Ref: BHE/PW/PUR/VNSR-CRH/1279/Corrigendum-04

Sub: Corrigendum -04 Issue of Clarification

JOB: PROVIDING SERVICES OF TOWER CRANE ON MONTHLY HIRING BASIS FOR RENOVATION & RETROFITTING OF EXISTING ELECTROSTATIC PRECIPITATORS & DUCTS WORK AT NTPC, VINDHYACHAL SUPER THERMAL POWER STATION

Tender Specification Number: BHE/PW/PUR/VNSR-CRH/1279

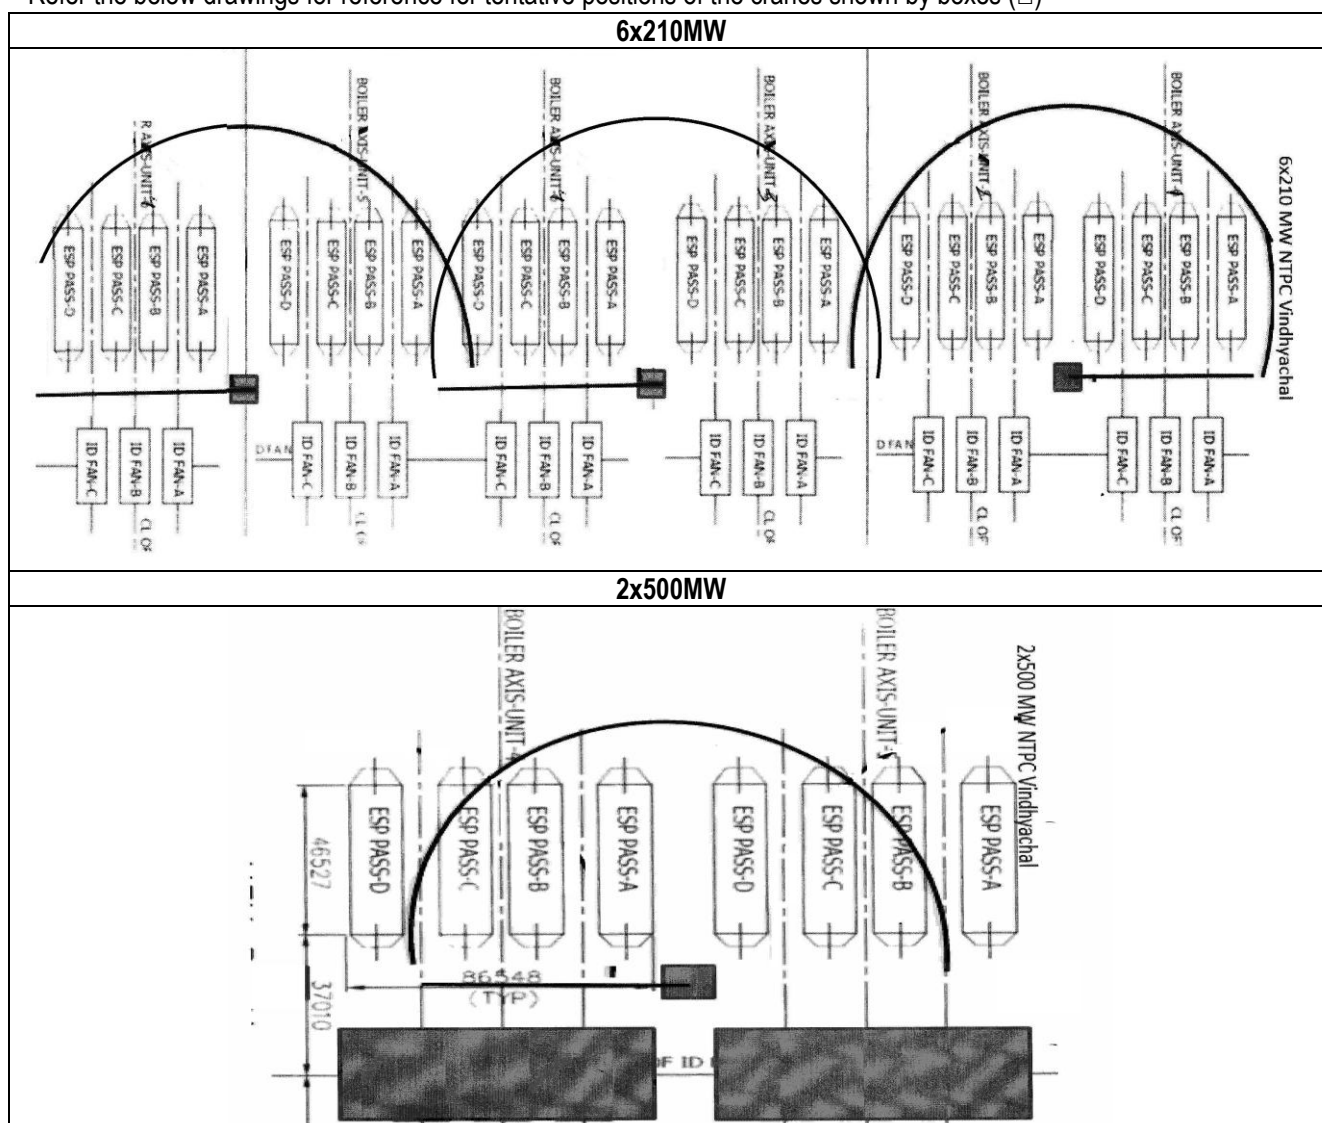
QUERY 5: CLARIFICATIONS RELATED TO L1 PRICE AND REVERSE AUCTION PROCESS – As per tender, foundation (if required) will be provided by BHEL. The cost of such foundation (for bidding purpose and calculating L-1 rate only) for each vendor will be communicated by BHEL to the vendors. Please mention no. of local shifting planned for the site as the total cost of foundation which will get added will vary in direct proportion to the number of times shifting will be done. Further, it is mentioned that the L-1 rate shall be calculated as landed cost to BHEL (including cost of foundation). Therefore, the reverse auction process for each vendor will need to be entered as their price bid + their foundation cost as communicated by BHEL. Please confirm.

CLARIFICATION 5: Request of bidder is noted. The no. of locations for erecting tower crane planned for 6x210MW ESP structure shall be Three (03) nos. (which means two shifting). Similarly, the no. of locations for erecting tower crane planned for 2x500MW ESP structure shall be One (01) no.

Refer the below drawings for reference for tentative positions of the cranes shown by boxes (□)
